# Access Compliance Report

## Public Rights-of-Way

### (Curb Ramps)

Intersection ID: 11889	Main Street: ASHLEY_RD	Cross Street: DUBLIN_RD	Location: W
ADA ID: 9BCA806A7CC1	Ramp Type: BlendTrans1	Initial Pass/Fail: Fail	Overall Compliance: No
		Severity Score: 8.75	
Codes/Mitigation Info/Possible Solution		Field Measurements/Component Compliance

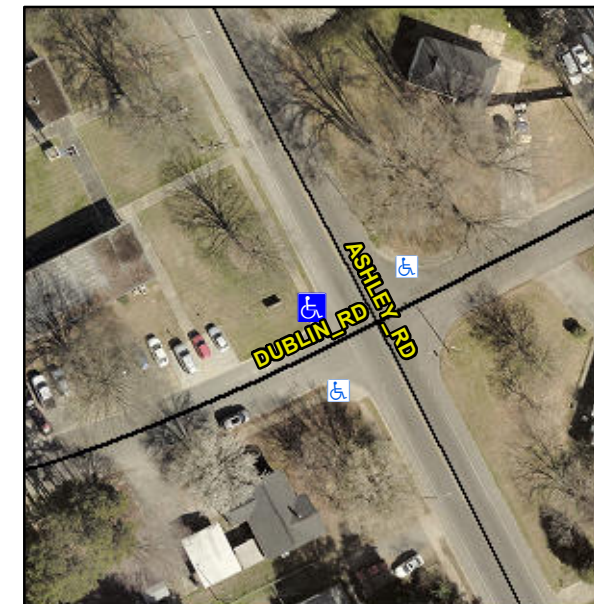
**Not Found, R304.5.1**

Compliance	Description	Data	Compliance	Description	Data
N/A	Ramp Length (in)	72.0	Yes	BlendTrans Slope (%)	2.3
No	Ramp Width (in)	39.5	Yes	BlendTrans XSlope (%)	1.9
N/A	Flare Type LT	N/A	N/A	Flare Type RT	N/A
N/A	Flare Slope LT (%)	N/A	N/A	Flare Slope RT (%)	N/A
N/A	Flare Traversable LT?	N/A	N/A	Flare Traversable RT?	N/A
N/A	Landing Length (in)	N/A	N/A	DWS Provided?	N/A
N/A	Landing Width (in)	N/A	N/A	DWS Contrast?	N/A
N/A	Landing Slope (%)	N/A	N/A	DWS Length (in)	N/A
N/A	Landing X Slope (%)	N/A	N/A	DWS Full Width?	N/A
N/A	Landing Curb? (Y/N)	N/A	N/A	DWS Offset (in)	N/A
N/A	Shared Landing?	N/A			
N/A	Gutter Ponding?	N/A	N/A	Gutter Slope (%)	N/A
N/A	Gutter Lip Ht (in)	N/A	N/A	Gutter X Slope (%)	N/A
N/A	Painted X Walk1?	No	N/A	Painted X Walk2?	N/A
	X Walk 1 Direction	To SE		X Walk 2 Direction	N/A
	X Walk 1 Width (in)	N/A		X Walk 2 Width (in)	N/A
	X Walk 1 Slope (%)	4.0		X Walk 2 Slope (%)	N/A
	X Walk 1 X Slope (%)	1.3		X Walk 2 X Slope (%)	N/A

N/A	Ramp inside XWalk1?	N/A	N/A	Ramp inside XWalk2?	N/A
	Road Slope (%)	1.3		Clear Space?	N/A
	Road X Slope (%)	4.0	N/A	Clear Space to XWalk (in)	N/A
N/A	Any Obstructions?	N/A	N/A	Storm Grate/Utility Hazard?	N/A
	Obstruction Type			Storm Grate/Utility Type	
		N/A			N/A
			Yes	Surface Condition? (G/P)	Good
			No	Curb Slope (%)	11.7

**Remove & Replace Curb Ramp With Two New Directional Ramps or Equivalent.**
